Subject: Architectural and Site Approval to permit a 20-unit multi-family development in an R1 zoning district pursuant to SB330 and Government Code Section 65 ASA-2024-005 Submittal #1
Address: 20739 Scofield Drive, Cupertino, CA 95014 | APN 359-09-016

PLAN REVIEW No. **24 3521**

Project: 20739 Scofield Drive- Architectural and Site Approval to permit a 20-unit multi-family development in an R1 zoning district pursuant to SB330 and Government Code Section 65

Project: 20739 Scofield Dr – Proposed 5-story, 20-unit residential building (ASA-2024-009, 1st Review)

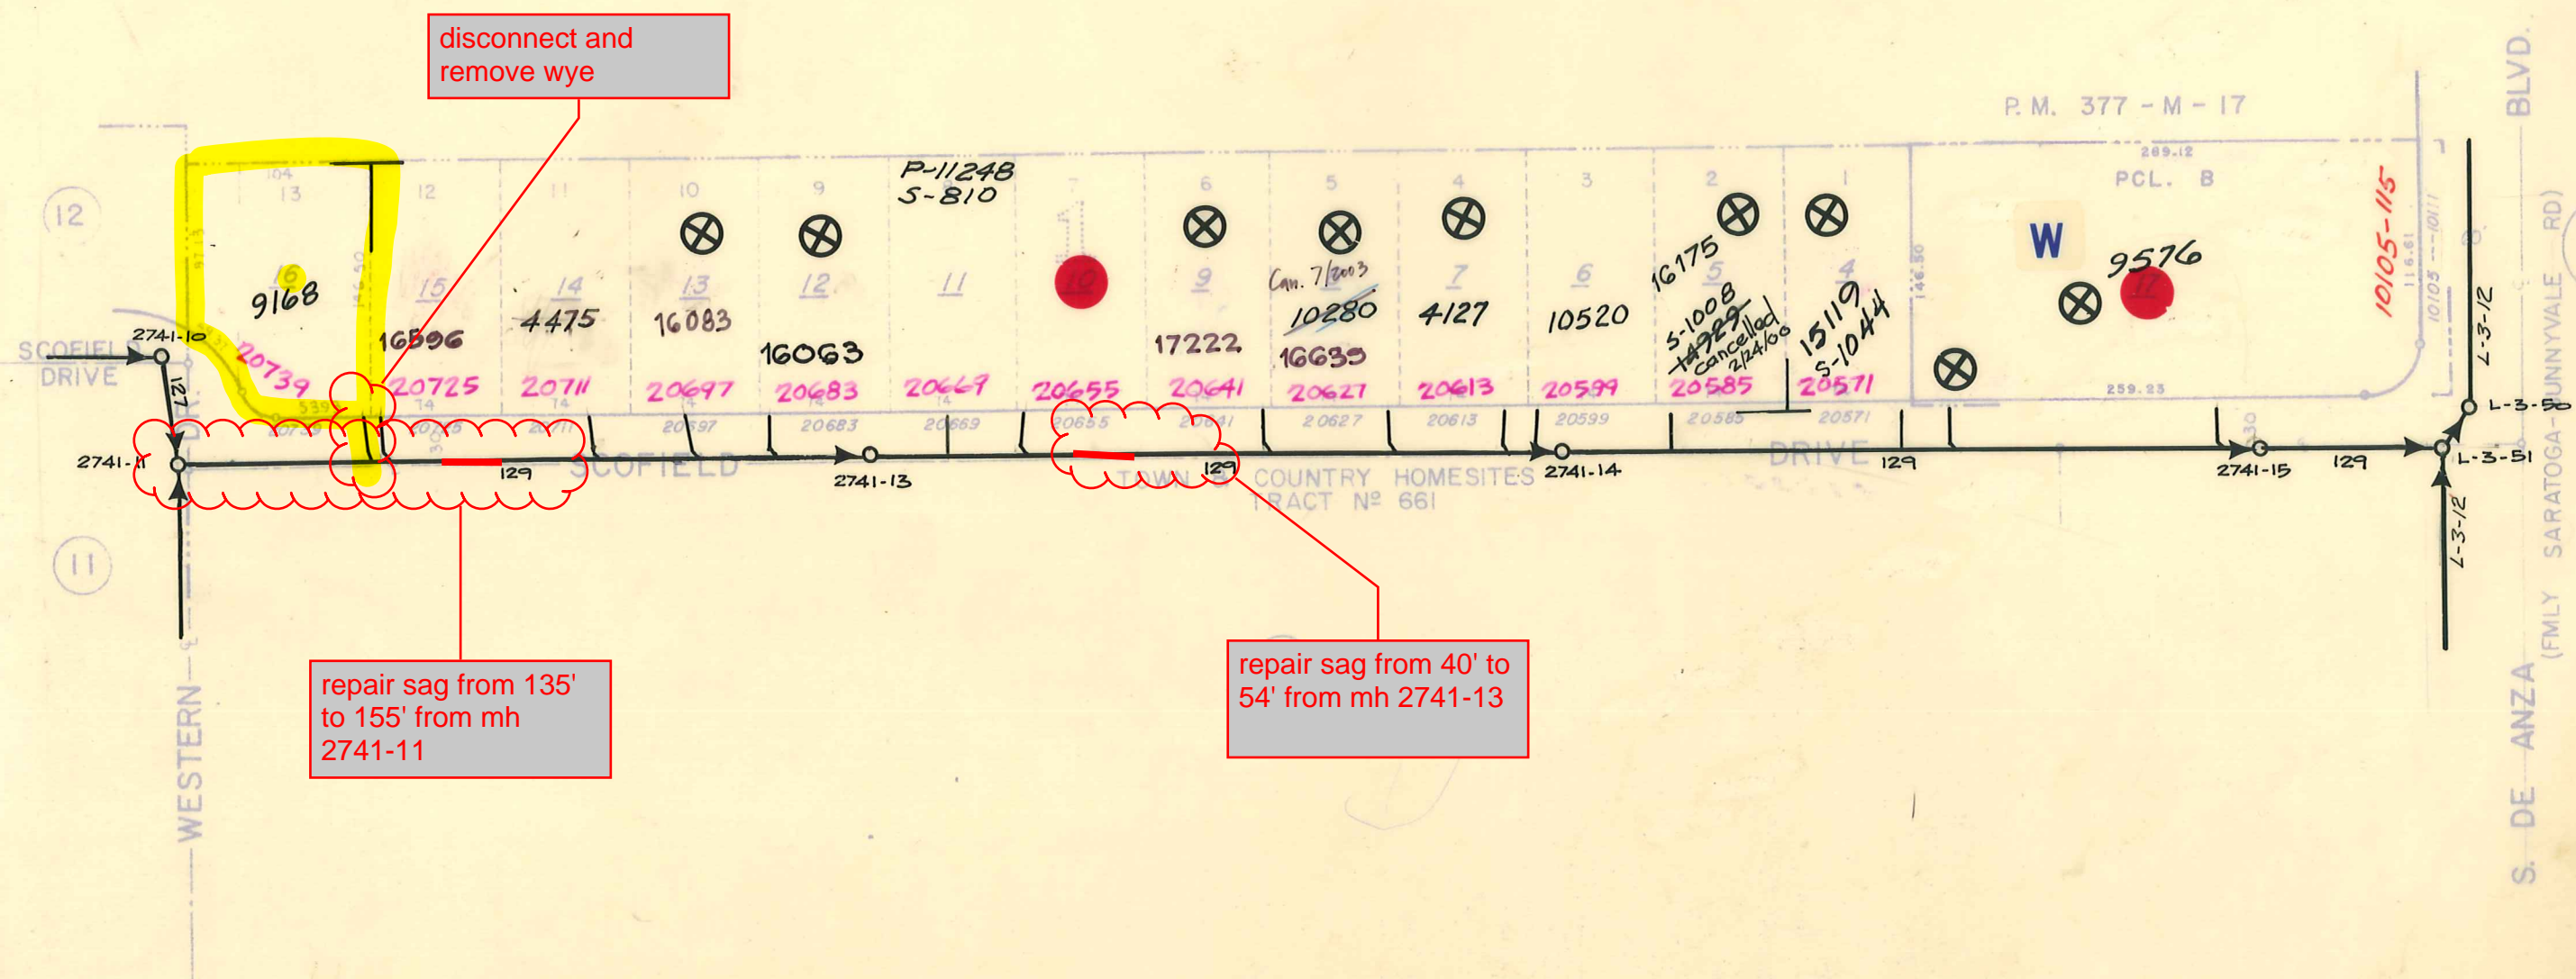
The Developer must repair the following defects and facilities downstream of their proposed connection point:

- Disconnect and remove existing sewer wye from sewer mainline
- Repair Sag from 135’ to 155’ from SSMH 2741-11.
- Repair Sag and Cracks from 40’ to 54’ from SSMH 2741-13.

disconnect and remove wye

repair sag from 135' to 155' from mh 2741-11

repair sag from 40' to 54' from mh 2741-13
